Memorandum to the City of Markham Committee of Adjustment

File: A/055/24
Address: 4345 14th Avenue
Agent: Delta Engineering Services (Ramesh Savaliya)
Hearing Date: Wednesday, July 10, 2024

The Applicant is requesting relief from the “Institutional and Open Space (O2)” zone under By-law 90-81, as amended, as it relates to an addition of a vestibule and a portico. The requested variances are to permit:

The Applicant is proposing the construction of a portico and vestibule for barrier free accessibility at the front entrance of the existing place of worship (the “Proposed Development”).

DRAWING TITLE: SITE PLAN, SITE STATISTICS

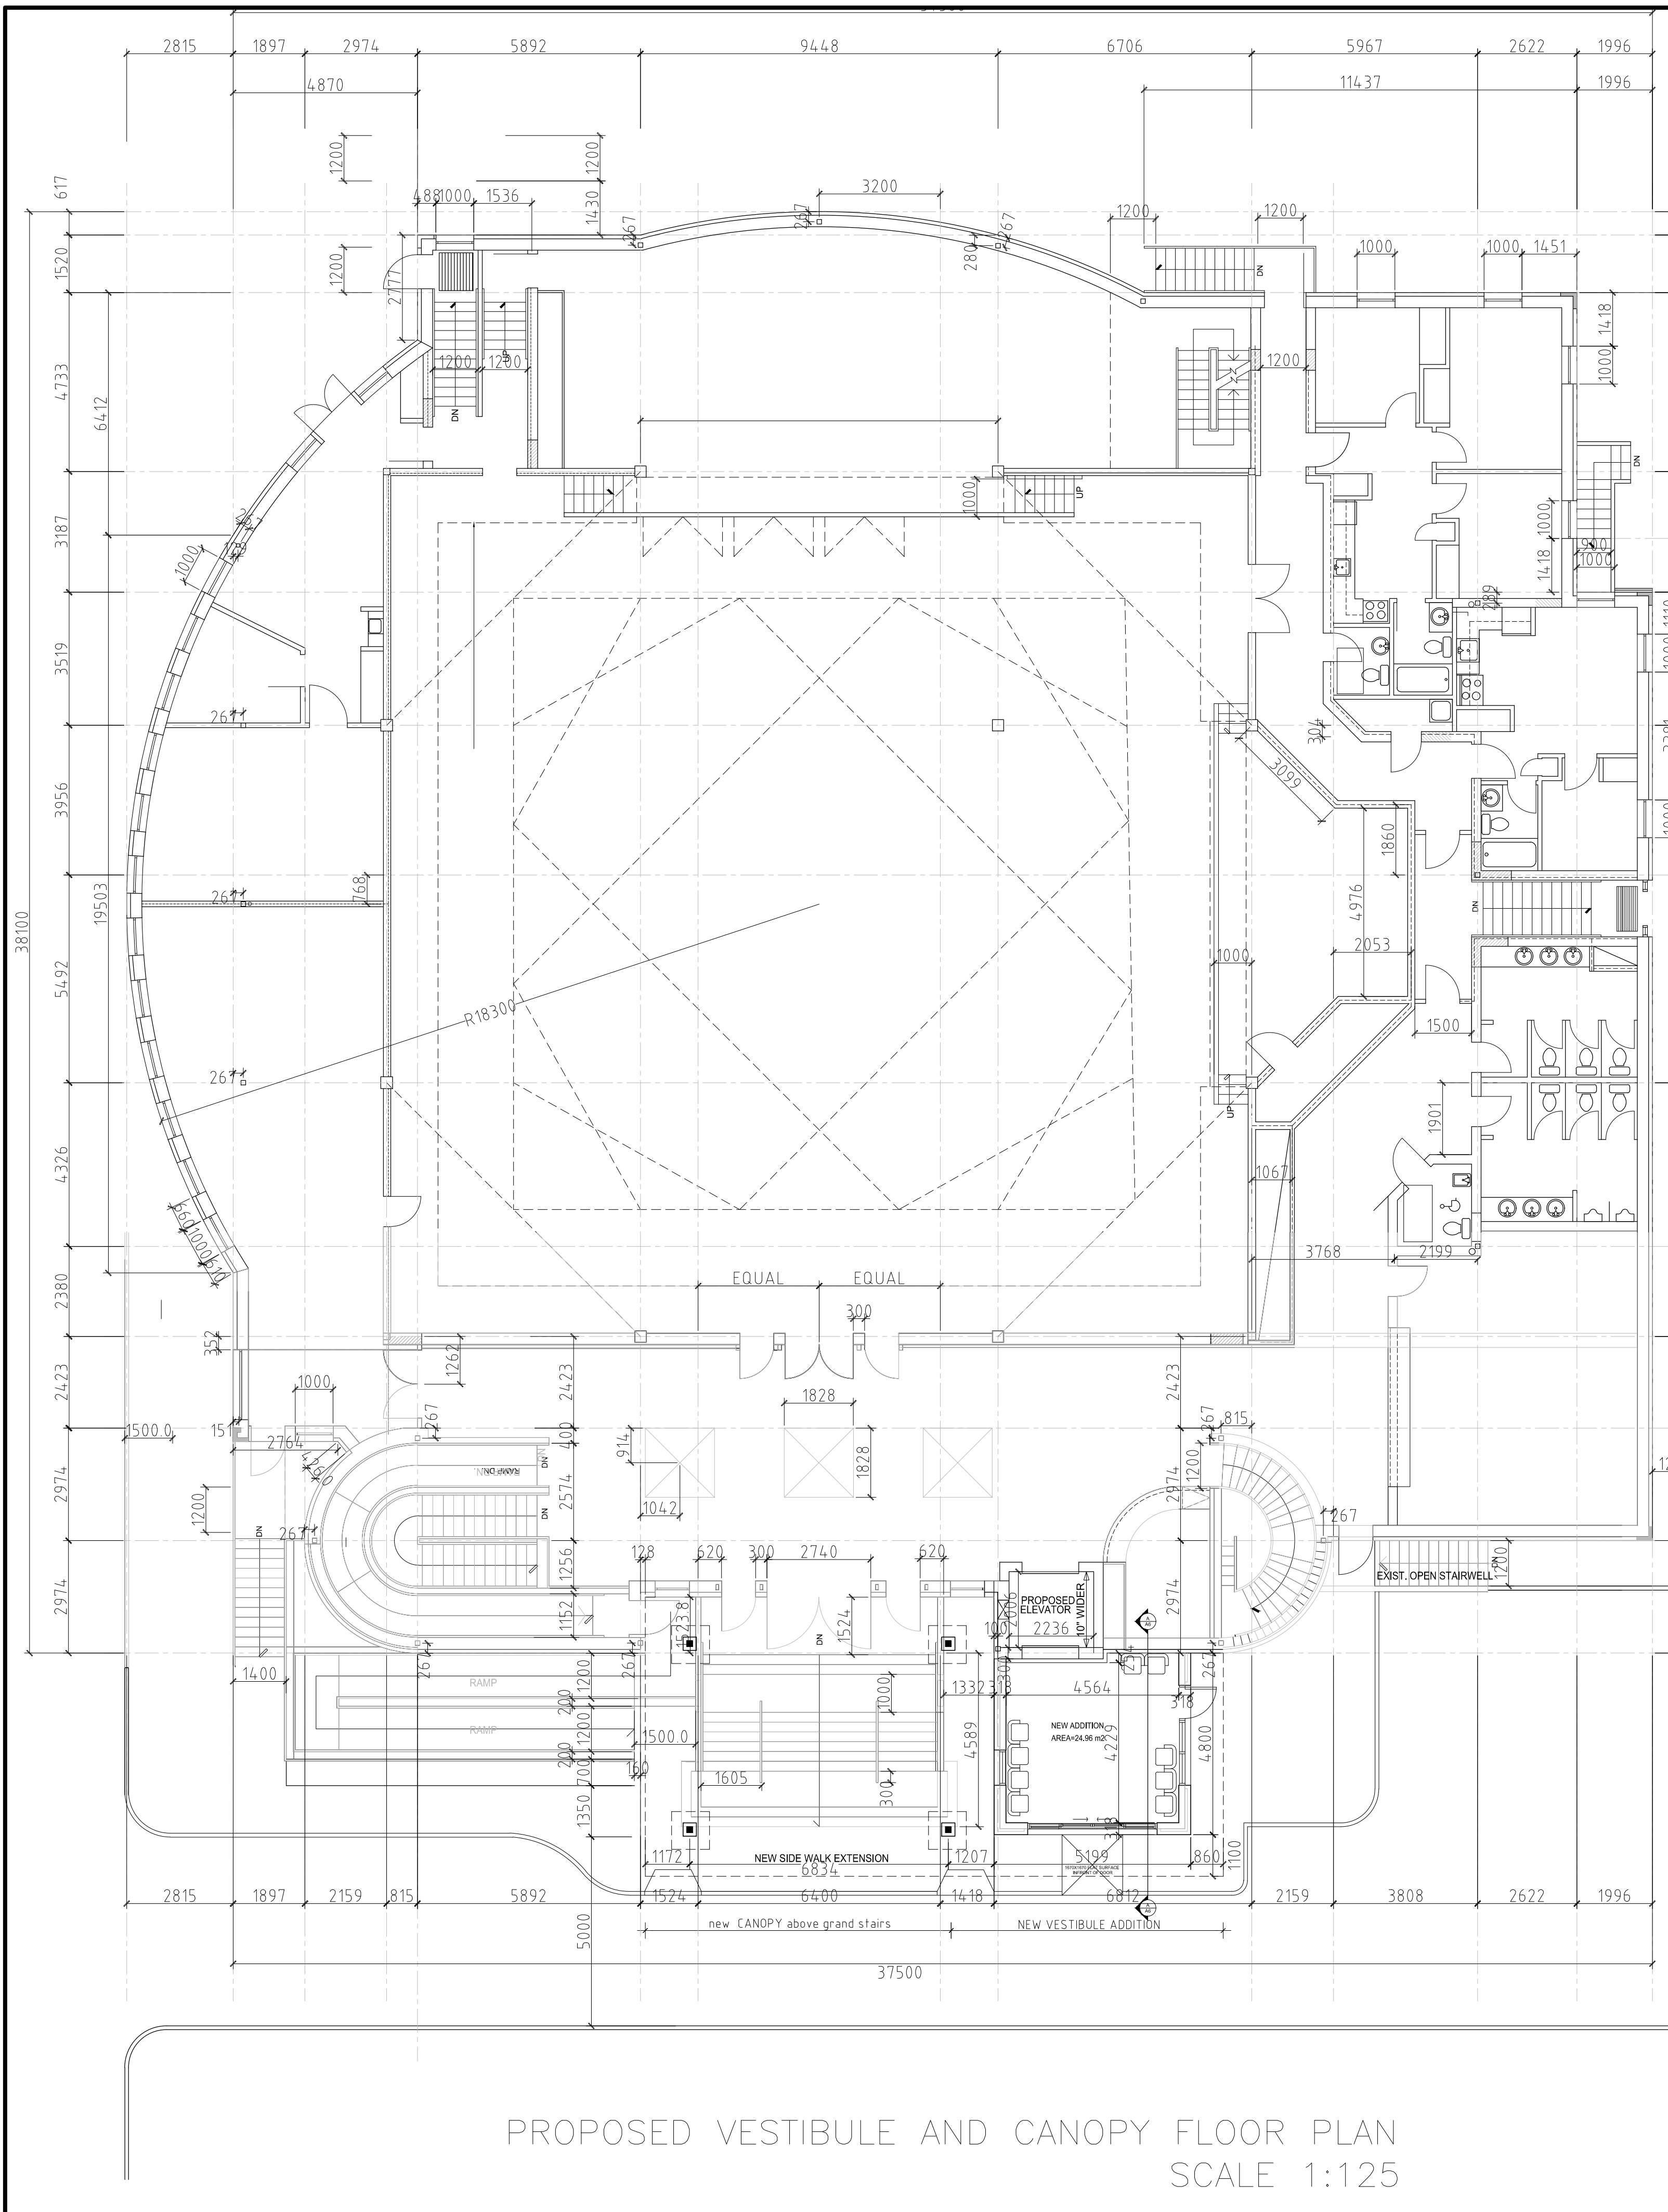
The Applicant is requesting relief to permit a minimum front yard setback of 23 m (75.46 ft), whereas the By-law requires a minimum front yard setback of 33 m (108.27 ft). This represents a reduction of approximately 10 m (32.81 ft). Staff note that the requested variance differs from what Zoning Staff identified through the permit review process [29 m (95.14 ft)], as well as the setback shown on the plans (refer to Appendix “B”).

The requested variance is entirely attributable to the construction of the portico above the main entrance of the existing place of worship. The main front wall of the building provides a front yard setback of approximately 33.64 m (110.37 ft) and is generally consistent with the pattern of established front yard setbacks on the street.

Staff note that the requested variance is to accommodate a future allowance for a vestibule and elevator addition at the rear of the proposed place of worship. This future addition is not shown on the plans (refer to Appendix “B”). Staff note that additional Planning applications and/or variances may be required to accommodate the future addition once plans have been submitted for Staff review.

Planning Staff recommend the subject minor variance application be deferred *sine die* until the Applicant submits plans that accurately reflect the full scope of work associated with the variances being requested.
